# Drainage Letter Report

1875 MAIN STREET  
COLORADO SPRINGS, COLORADO  
80911

April 18, 2019

PCD File No. PPR198

EX1

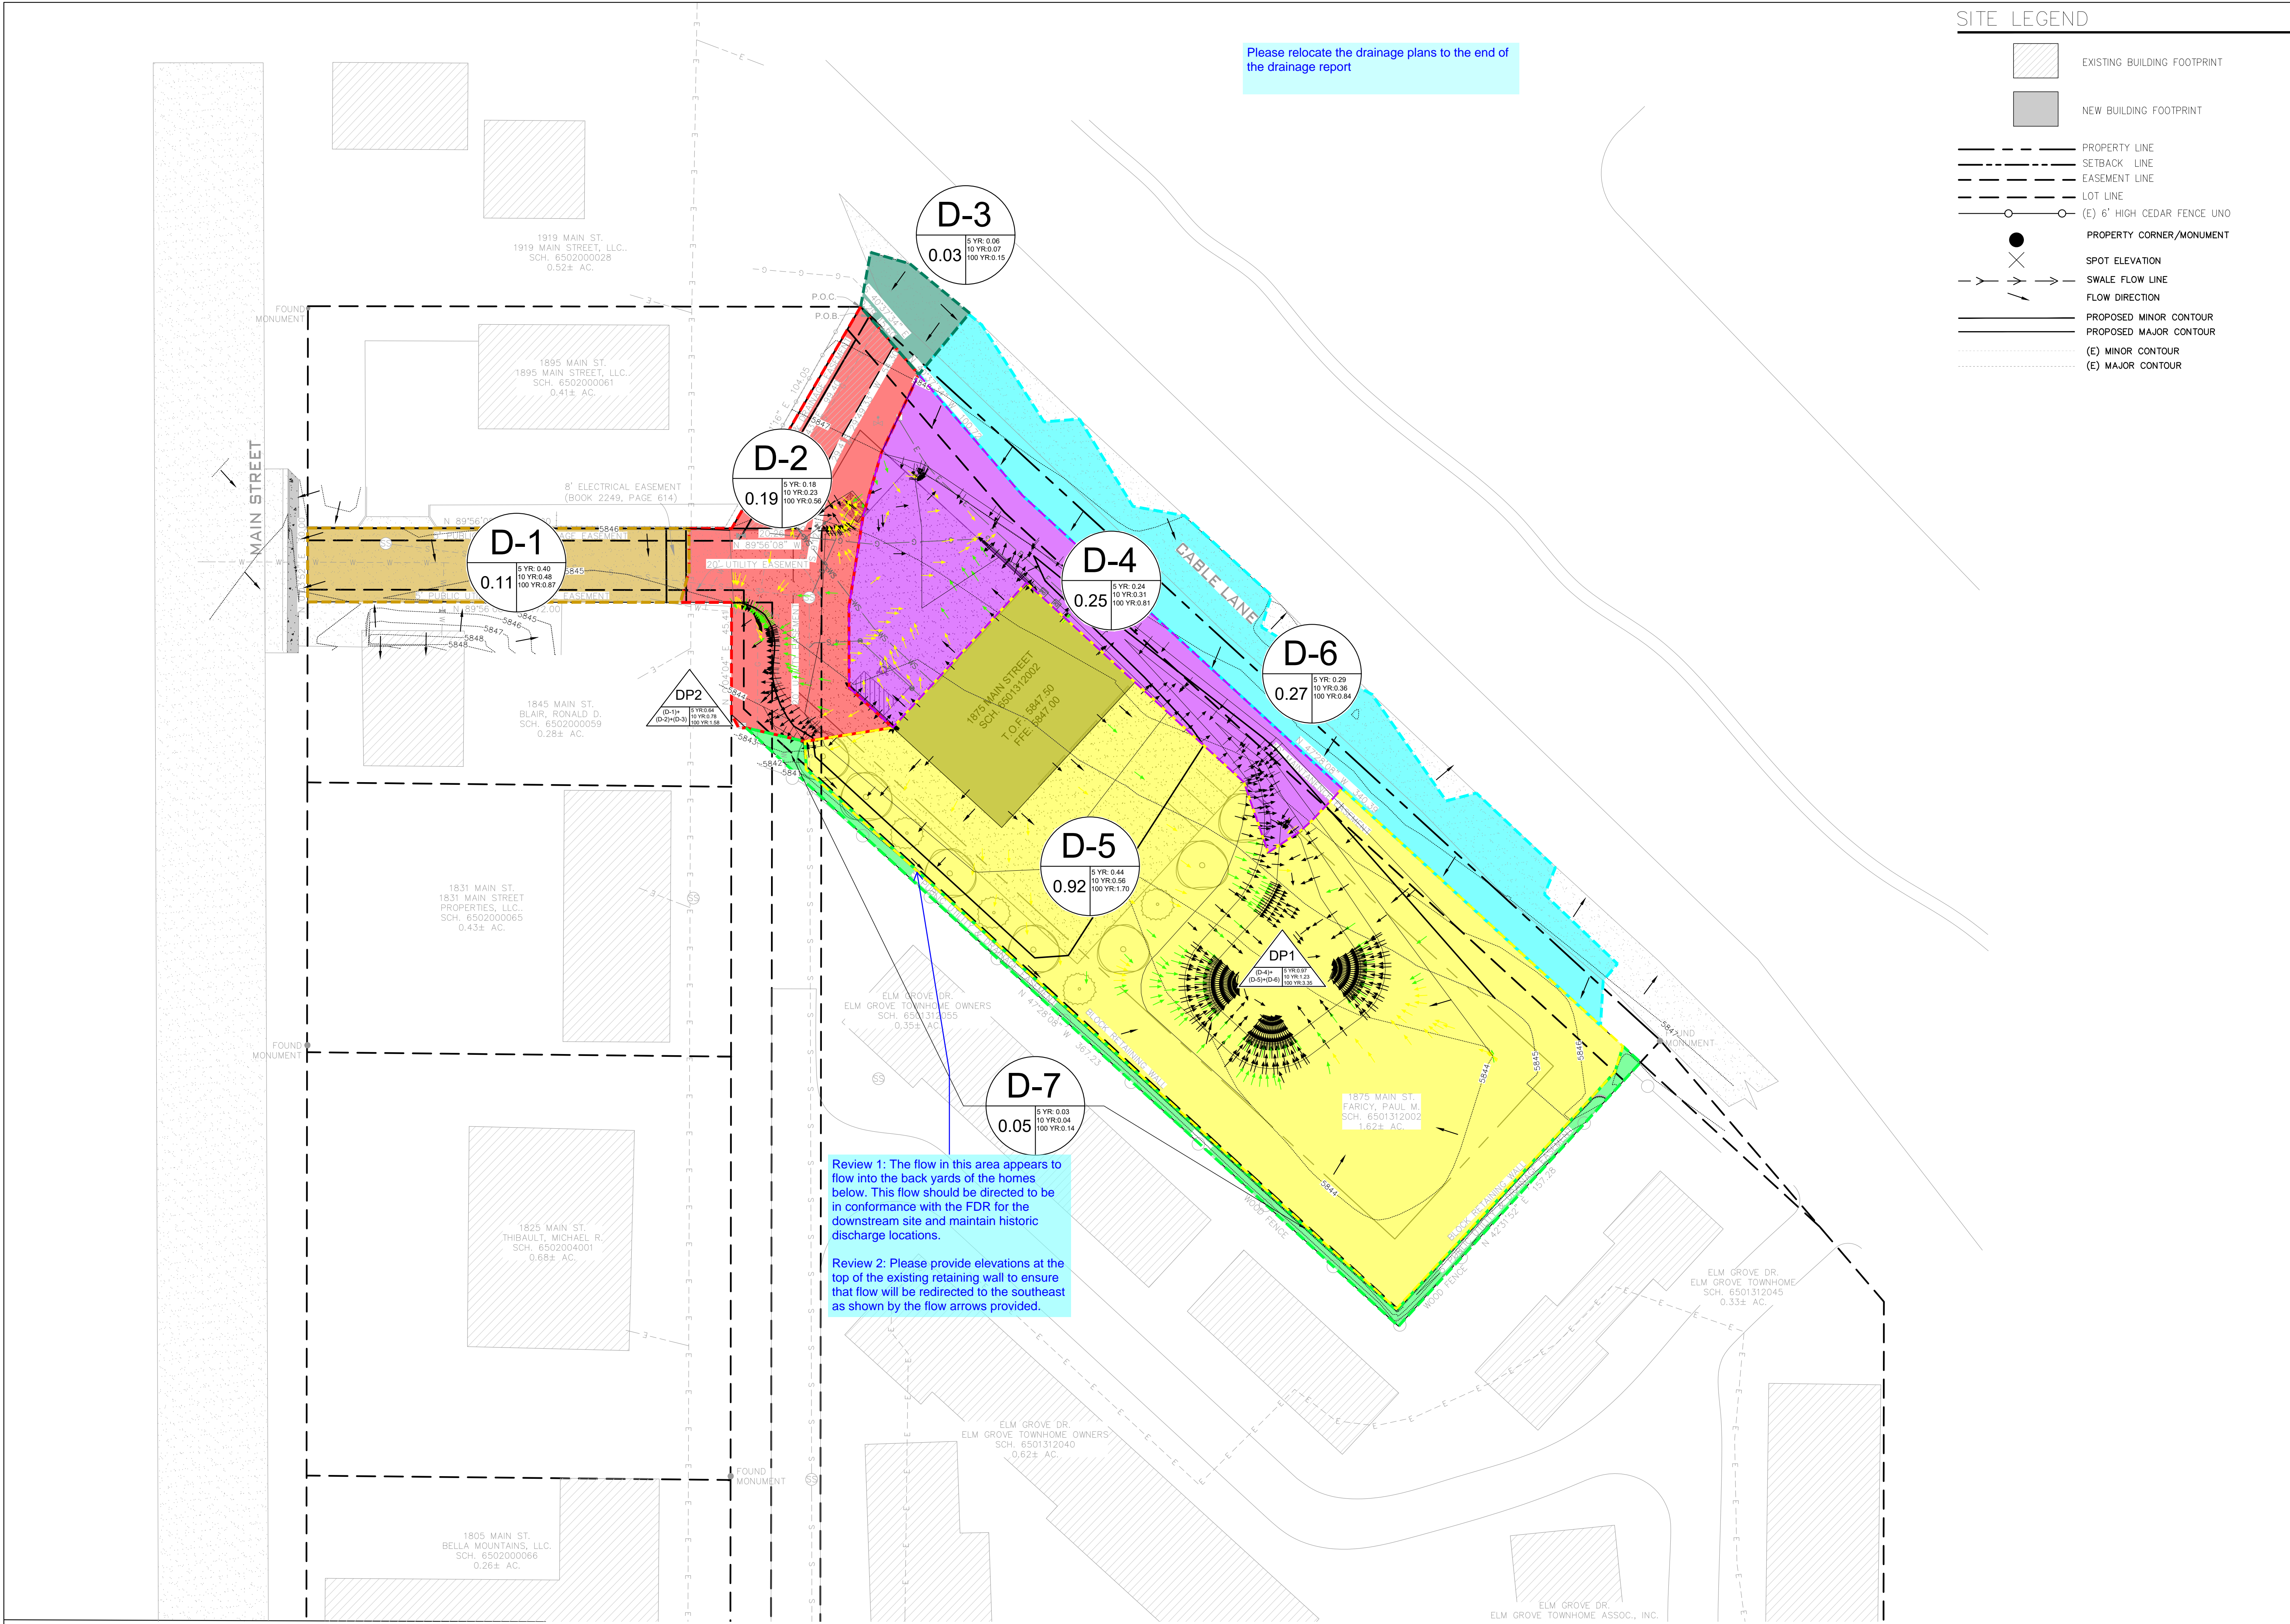
**Review 1:** The flow in this area appears to flow into the back yards of the homes below. This flow should be directed to be in conformance with the FDR for the downstream site and maintain historic discharge locations.

**Review 2:** Please provide elevations at the top of the existing retaining wall to ensure that flow will be redirected to the southeast as shown by the flow arrows provided.

EXISTING CONTIONS SUB-BASIN DELINEATION EXHIBIT  
PCD FILE NO: PPR198

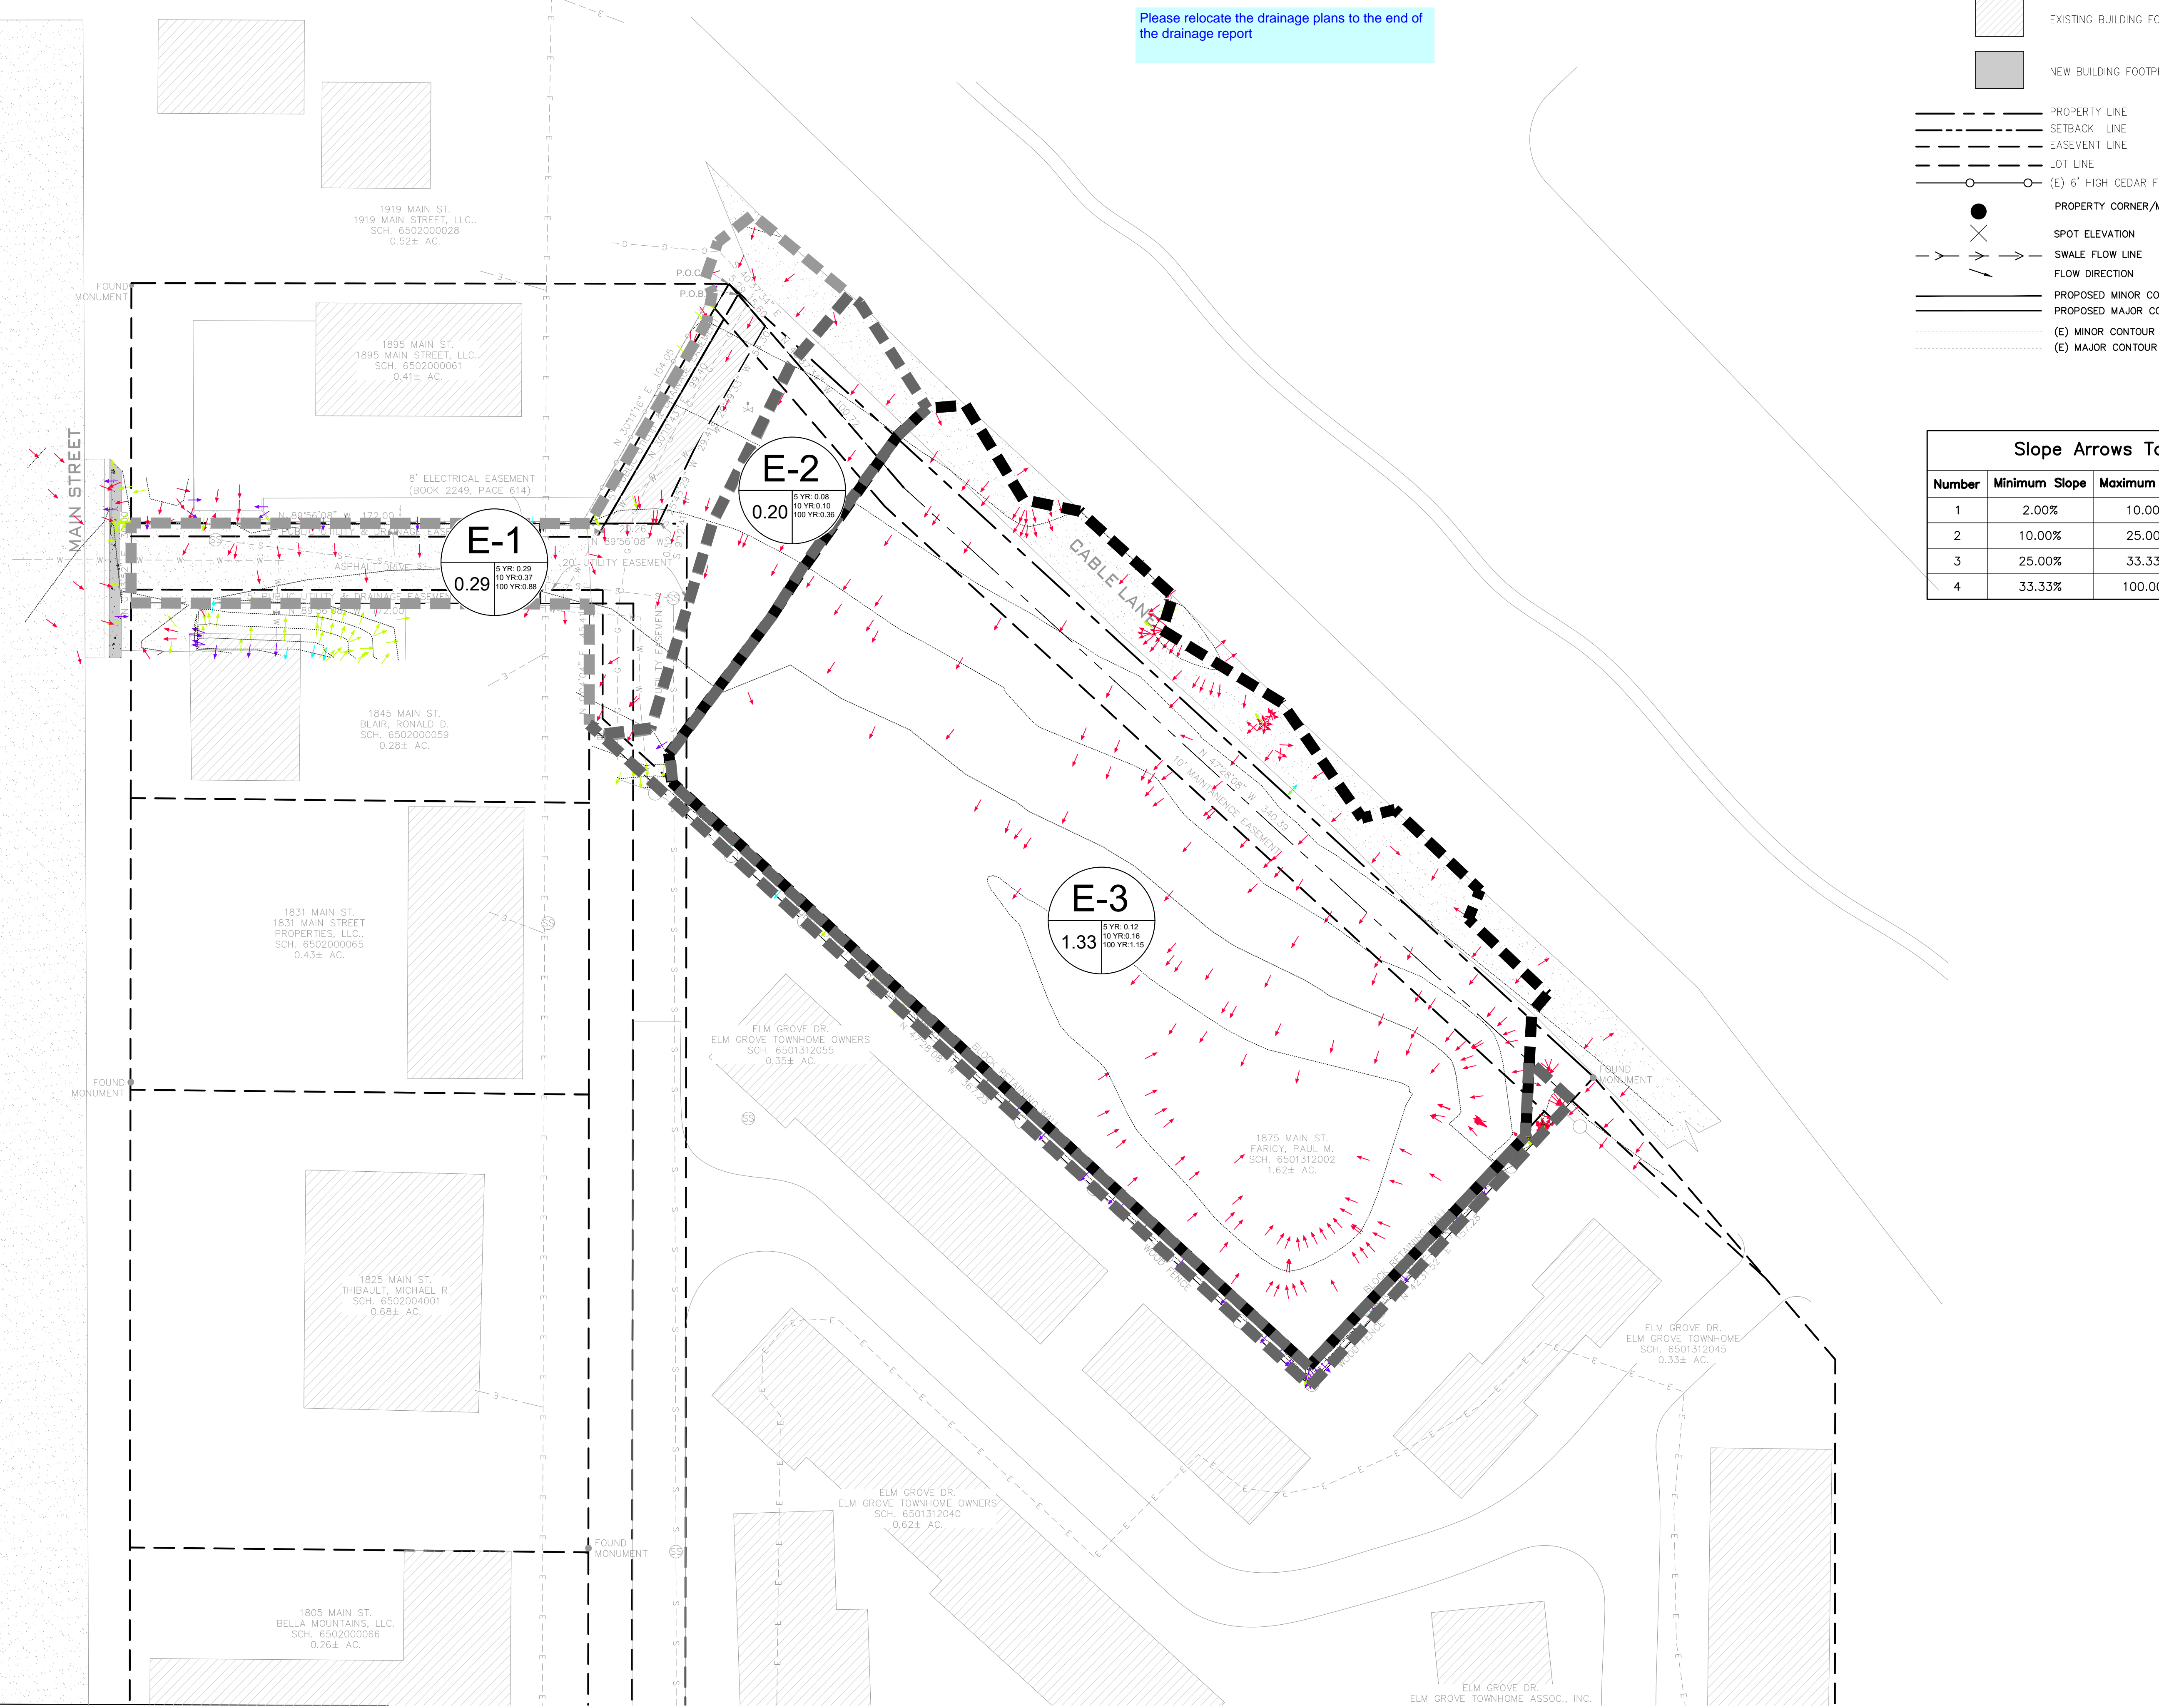
Please relocate the drainage plans to the end of the drainage report
